Federal Agency Progress Evaluation

Prepared for
Environmental Protection Agency,
Chesapeake Bay Program Office
March 19, 2021

Appendix B: Comment Log

Figure 3-9. Percent reduction required from the 2019 Progress scenario to achieve potential TN FPGs in Washington, D.C.

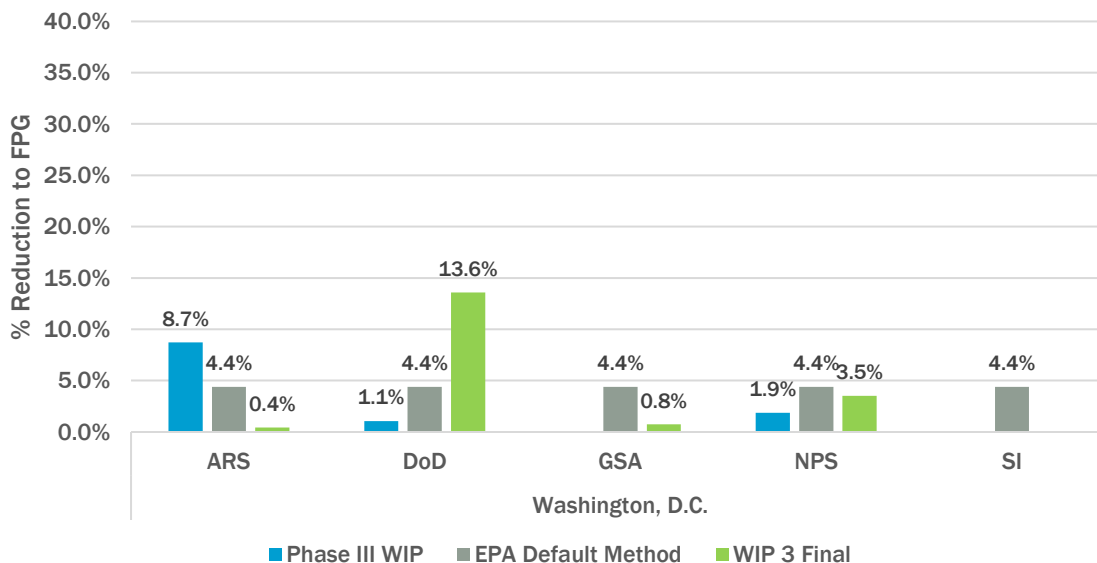
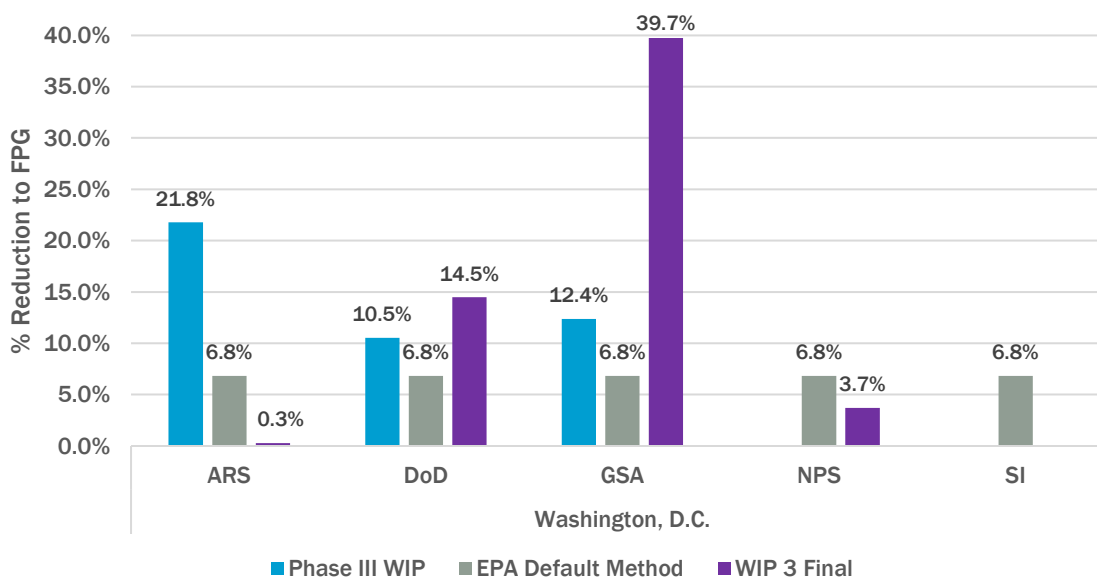
52	Draft Final	John Maleri	DOEE	3-15	1	DOEE expects federal agencies to achieve the load reductions documented in the Phase III WIPs, not the modeled loads in the WIP 3 Final scenario.	Can it be noted that in almost every example DOEE is requiring a less aggressive level of effort as compared to 2019 progress for DC's FPGs (Phase III WIP, in the graph) as compared to the level of effort provided by the agencies themselves (WIP 3 Final). That point is getting lost a bit.	Revised - Revision accepted. "DOEE expects federal agencies to achieve the load reductions documented in the Phase III WIPs, not the modeled loads in the WIP 3 Final scenario, and in almost every case, the Phase III WIP FPG requires a lower level of effort than the agency's WIP 3 Final scenario inputs."
53	Draft Final	John Maleri	DOEE	3-15	1	As shown in Figures 3-9 and 3-10, some agencies (GSA, NPS, Smithsonian) have achieved some FPGs from the Phase III WIP and WIP 3 Final scenario.	Can it be noted that while some agencies 2019 Progress totals are below the FPG for 2025, these agencies will still be required to account for any changes in loads moving forward towards 2025 based on development or land use change.	Revised - Revision accepted. "In those cases, the federal agency is still expected to offset increases in loads due to development or land use changes."
